December 23, 2009
RC-09-0159

**Subject: VIRGIL C. SUMMER NUCLEAR STATION (VCSNS) UNIT 1
DOCKET NO. 50/395
OPERATING LICENSE NO. NPF-12
RESPONSE TO REQUEST FOR ADDITIONAL INFORMATION
FOR LICENSE AMENDMENT REQUEST - LAR-04-02911 (ALTERNATIVE
SOURCE TERM)**

Control Building Plan View 463' Elevation (from enclosure 8.4 of SSP-001):

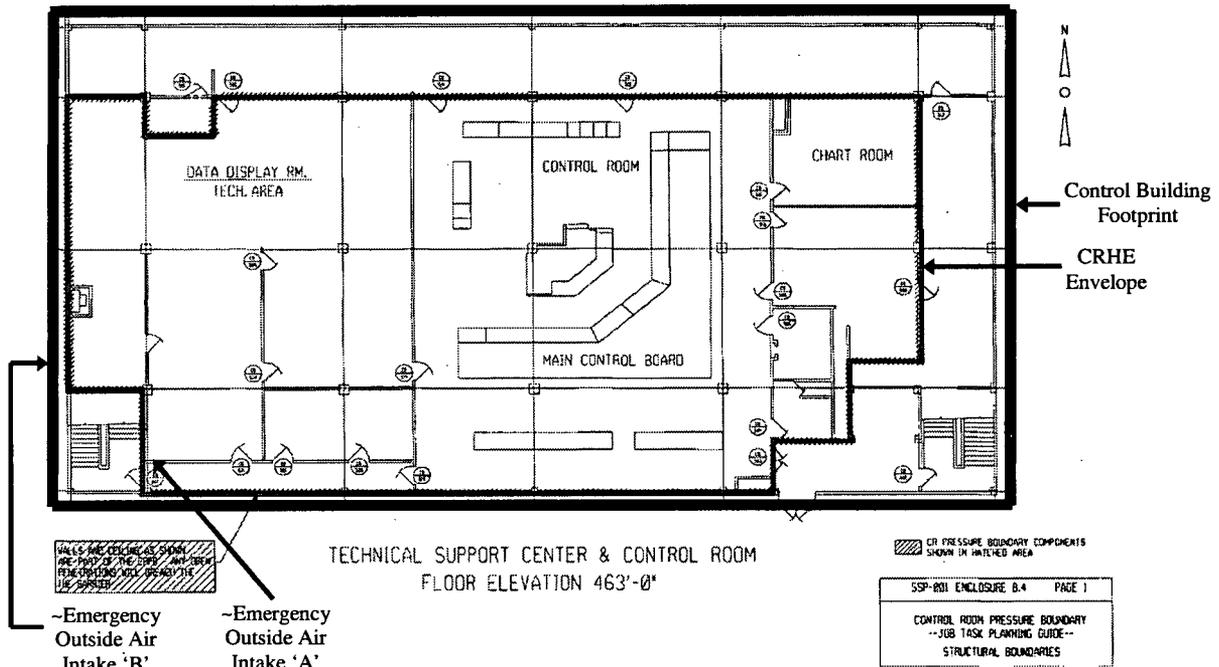
- Confirm that the directions from the intake to release are as follows: a) MS POR 'A' to Intake 'A' is 64°, b) MS SR's 'A' to Intake 'A' is 57°, c) RWST Overflow to Intake 'A' is 22°, and d) RWST Overflow to Intake 'B' is 18°.

The atmospheric dispersion factors used as input to dose assessments from control room unfiltered leakage were taken from calculation DC00040-079, Revision 1. This calculation determined the relative concentrations at the control room emergency outside air intakes 'A' and 'B' (shown in the two figures above) from several release points.

RESPONSE:

The directions to MS POR 'A' were slightly inaccurate in Calculation No. DC00040-079 while the directions and distances for the RWST were reversed. The direction of 57° for MS SR's 'A' to Intake 'A' was acceptable. The original and updated values are shown as follows:

Release Point	Direction from Intake to Release			
	DC00040-079 Values		Updated Values	
	Intake 'A'	Intake 'B'	Intake 'A'	Intake 'B'
MS POR 'A'	64°	59°	49°	52°
RWST Overflow	22°	18°	18°	22°
	Straight-line Horizontal Distance (m)			
RWST Overflow	51.9	55.7	55.7	51.9
